PCN – Product Change Notification

PCN-A-100926

PCN Topic: 7”, 10.1”, and 10.4” Panel PC Current IP65 Front 10mm bezel are replaced by New IP65 Front 6mm bezel

Mechanical Dimension (For Example: R10IA7T-IPP1)

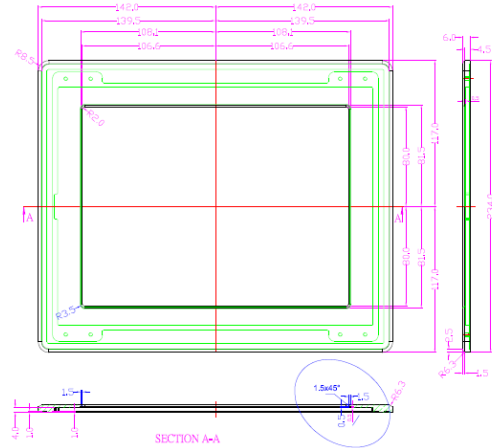
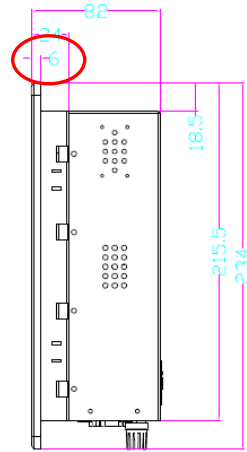
Current 10mm Front Bezel

Total Dimension: L*H*D=284*234*10mm
Thickness: 10mm

New 6mm Front Bezel

Total Dimension: L*H*D=284*234*6mm
Thickness: 6mm
